ENGINEERING ORDER

CONTRACT MODIFICATION: ONE
DATE: OCTOBER 1991

SUBJECT: REMEDIAL ACTION, 881 HILLSIDE, PHASE IIA - PROCESS TREATMENT SYSTEM
AUTH NO. 986147, CONTRACT NO. 93057WF

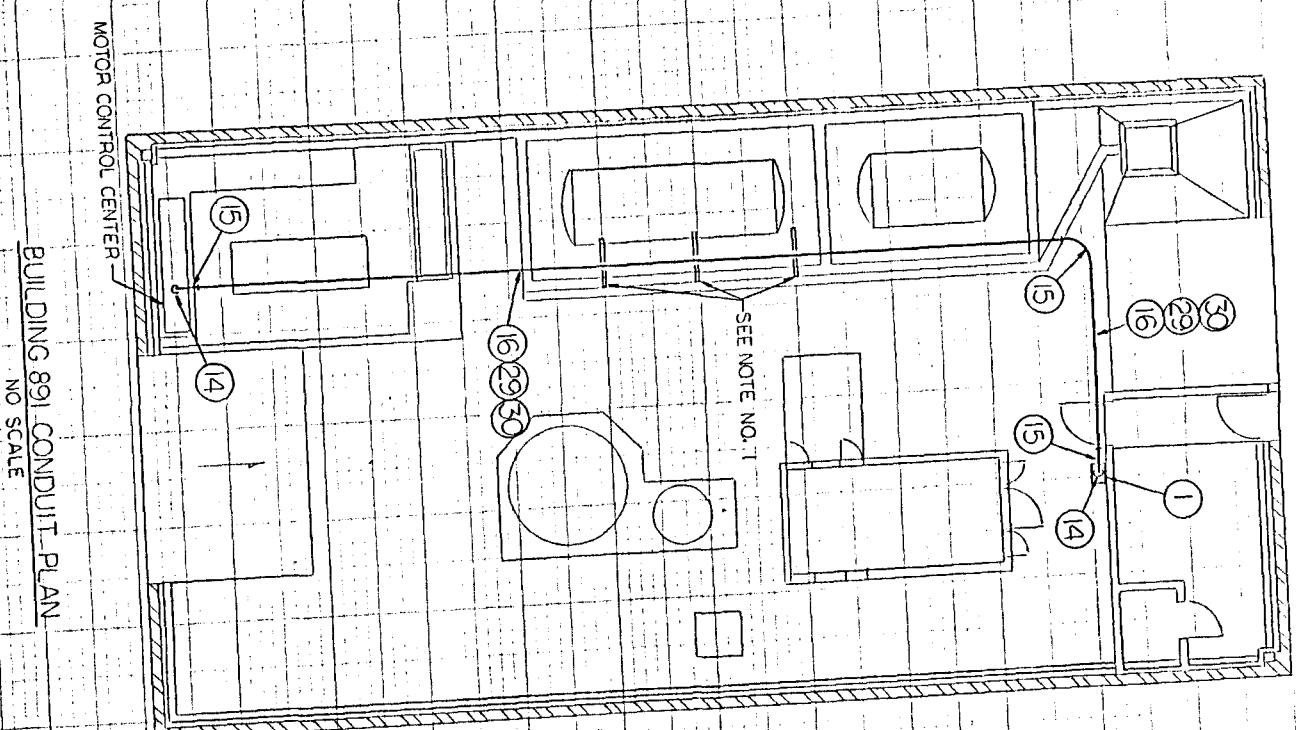
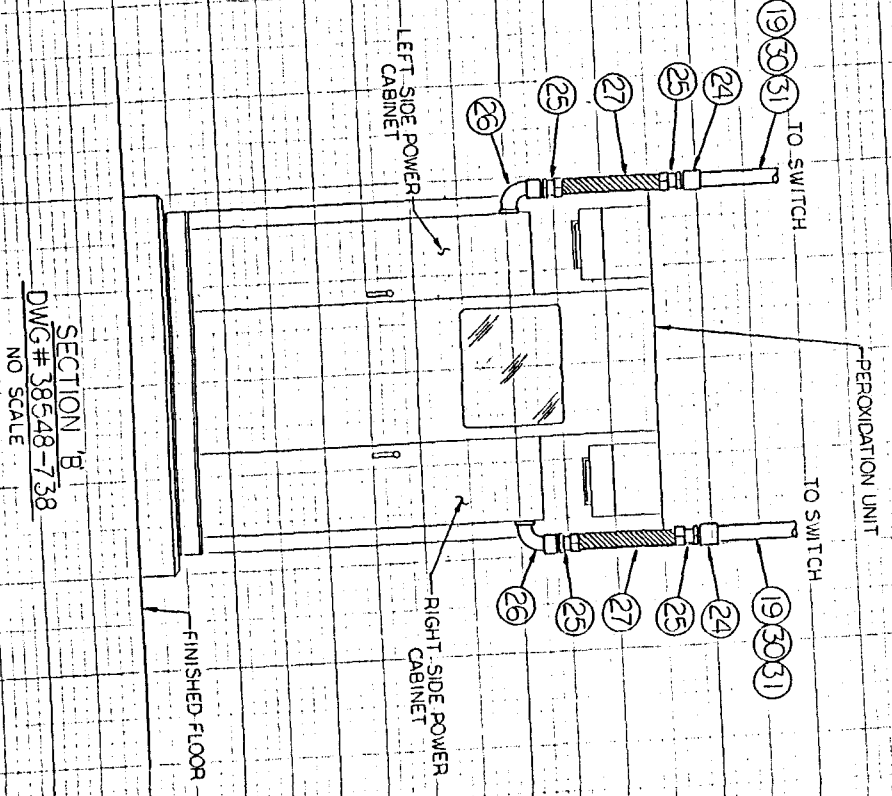
1. The Contractor shall install two (2) 200 amp switches and Junction box mounted on B-line channel frame to feed Peroxidation unit per new Drawings 38548-738 and 38548-739.
2. The Contractor shall add 3" GRC to existing conduit supports for 3 #600 KCMIL, Type THHN, and 1 #4/0 AWG, Type THHN, ground to feed unit from existing MCC section per Drawing 38548-739.
